MONTGOMERY COUNTY HISTORIC PRESERVATION COMMISSION
STAFF REPORT

Address:	7823 Overhill Rd., Bethesda	Meeting Date:	9/6/2023
Resource:	Contributing Resource Greenwich Forest Historic District	Report Date:	8/30/2023
Applicant:	Michael Bern & Rachel Roth Luke Olson, Architect	Public Notice:	8/23/2022
Review:	HAWP	Tax Credit:	Partial
Permit No.:	REVISION 967939	Staff:	Dan Bruechert
Proposal:	Porch repairs and alterations and fence installation.

Figure 2: Proposed gate location (circled in red) and fence design.

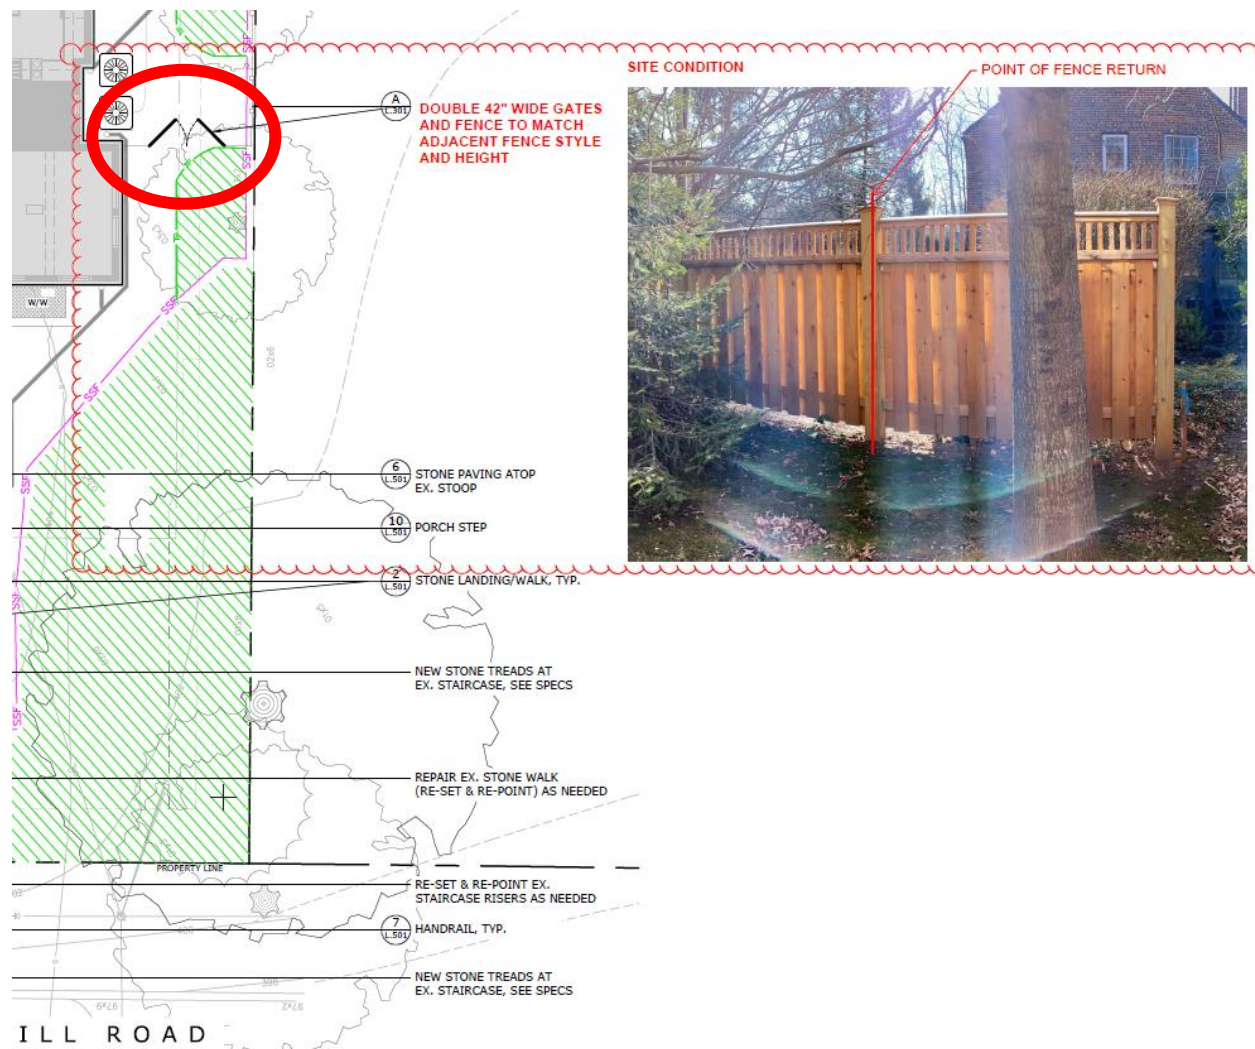
Staff finds the proposed fence and gate are consistent with the previous approval and satisfy the height, material, and setback requirements for fences in D9. Staff recommends the HPC approve the fence under the Design Guidelines and 24A-8(b)(2) and Standard 2.

BERN RESIDENCE
7823 OVERHILL RD, BETHESDA, MD
SITE PLAN

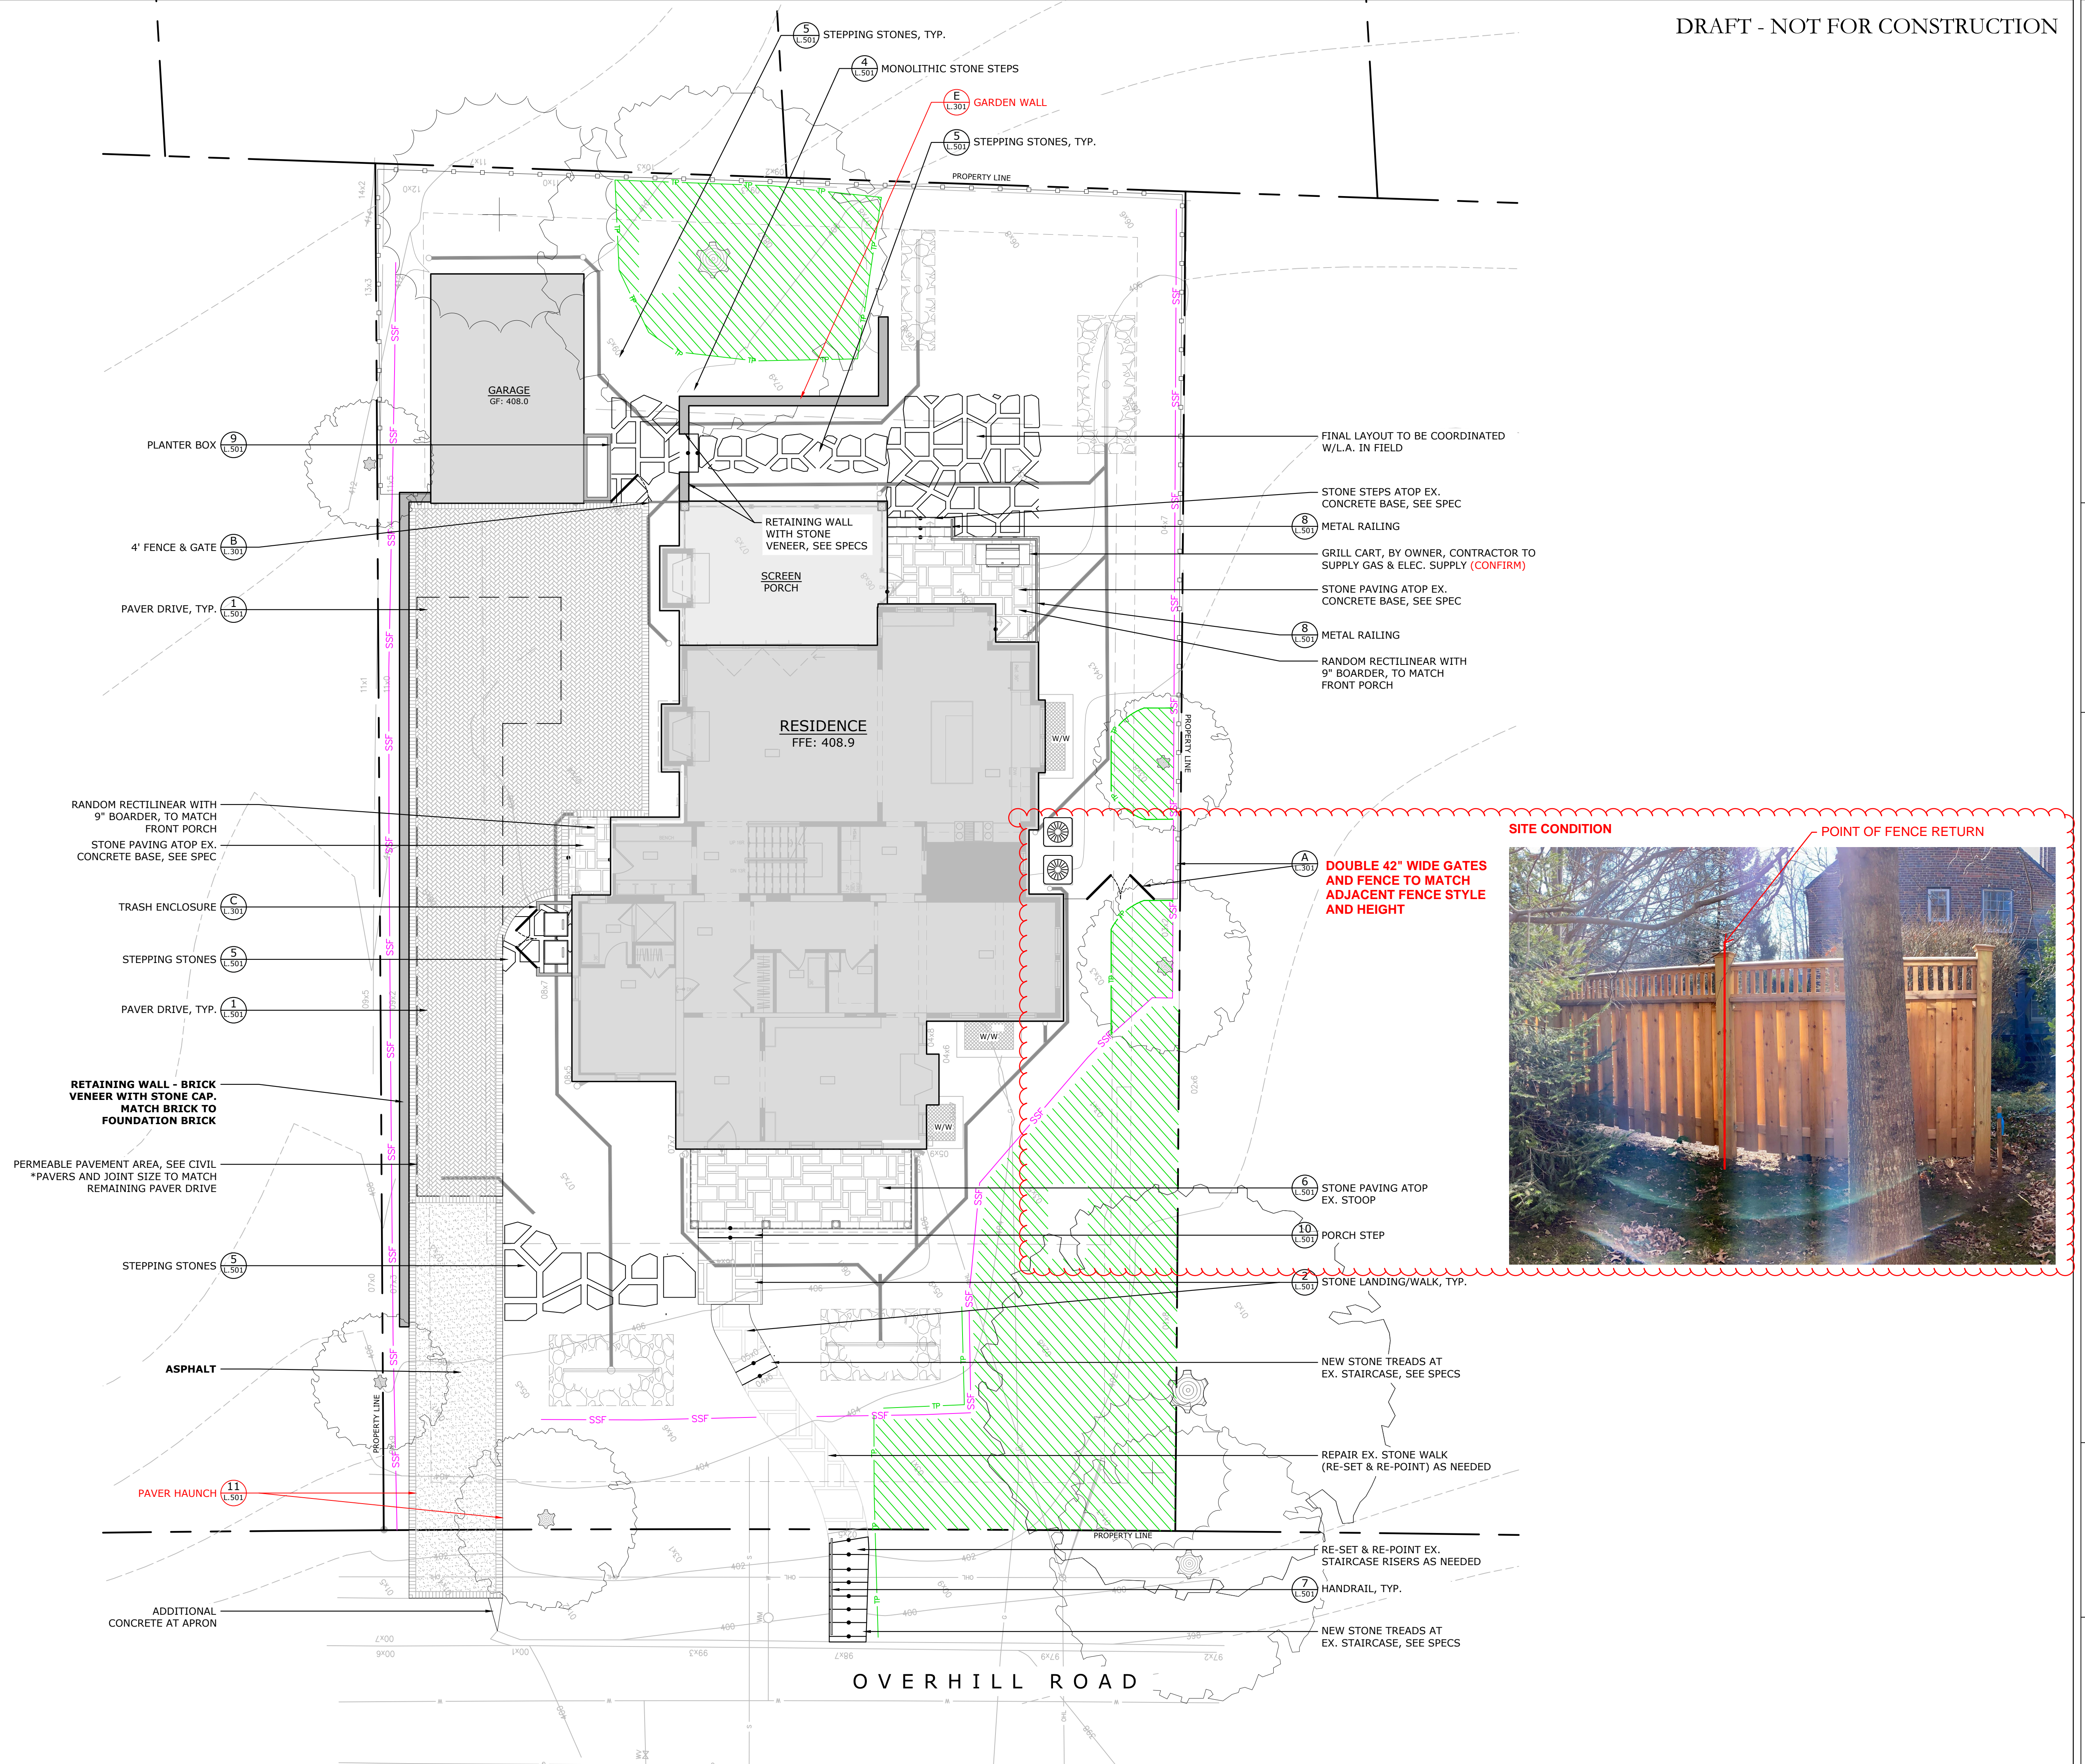
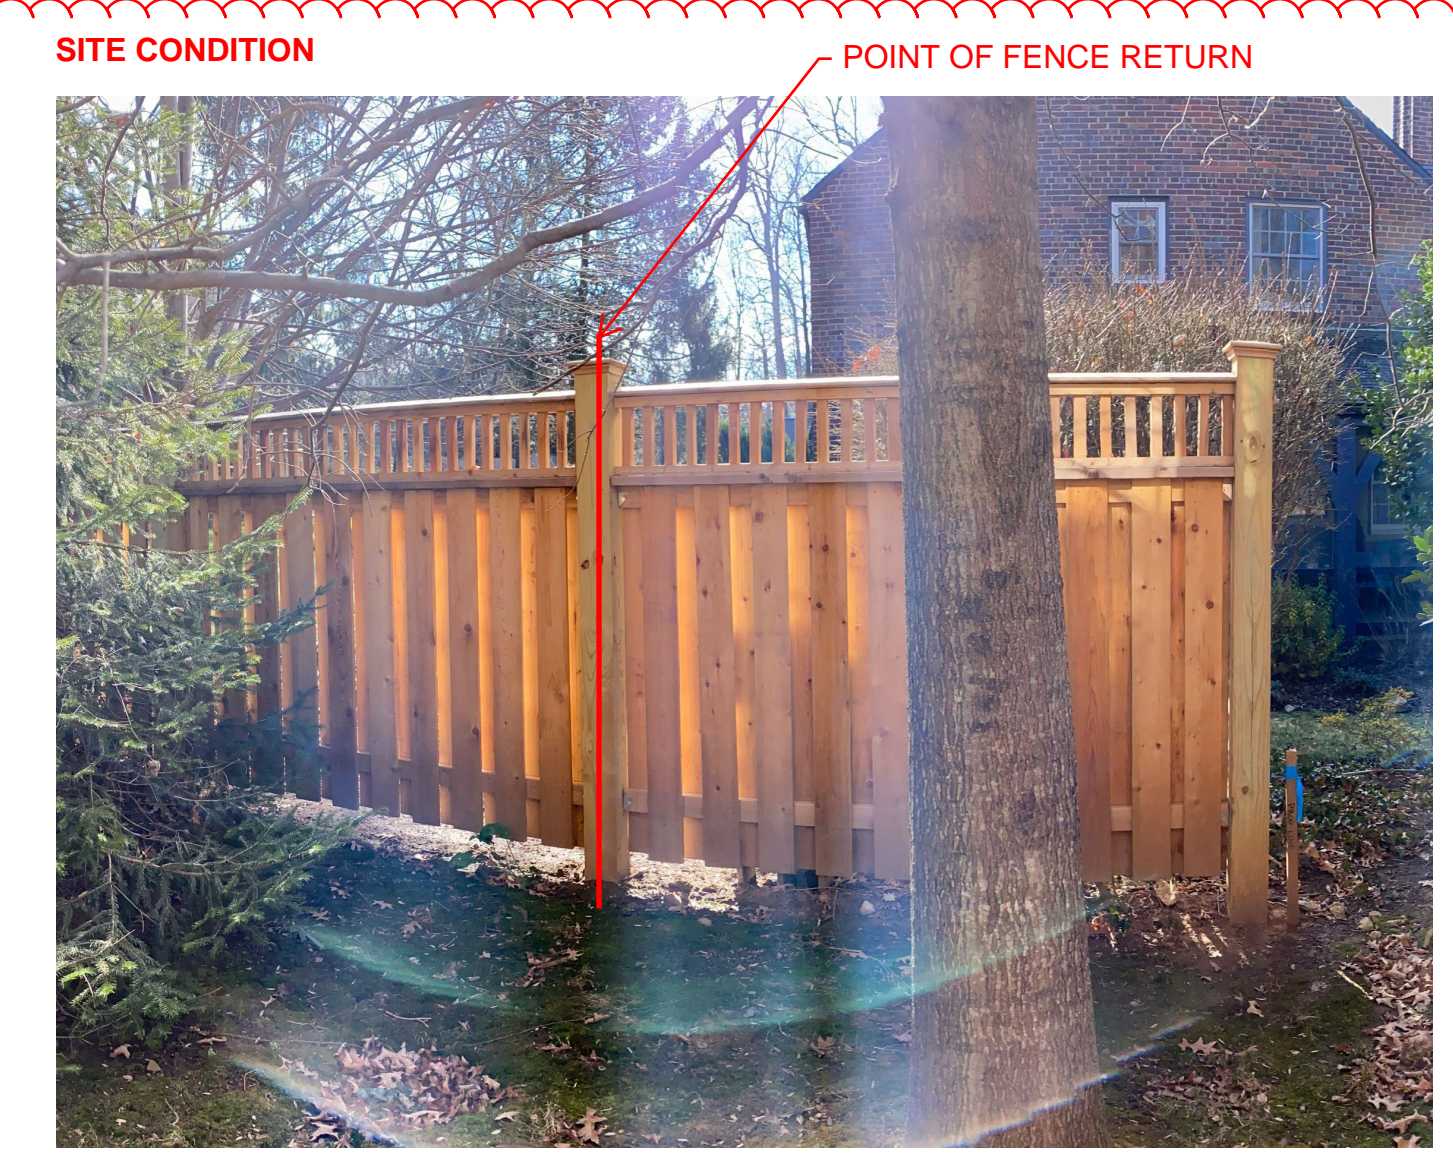
REPLACE EXG. WOOD COLUMNS/PILASTERS WITH PTD. FIBERGLASS COLUMNS, MATCH DIAMETER, BASE, CAP AND NECKING PROFILES AS CLOSELY AS POSSIBLE, REDUCE HEIGHT BY 2" TO ACCOUNT FOR NEW FLAGSTONE AT FRONT PORCH

REPOINT EXG. BRICK BASE, REMOVE. REINSTALL BRICK ROWLOCK COURSE FLUSH WITH BRICK BELOW AND ADD NEW 2" FLAGSTONE COPING AT PERIMETER WITH 3/4" RANDOM RECTANGULAR FLAGSTONE FIELD ABOVE EXG. CONC. SLAB

1. The replacement columns shall be wood. Revised plans and material specifications showing this change shall be submitted to staff prior to the approval of the building permit.
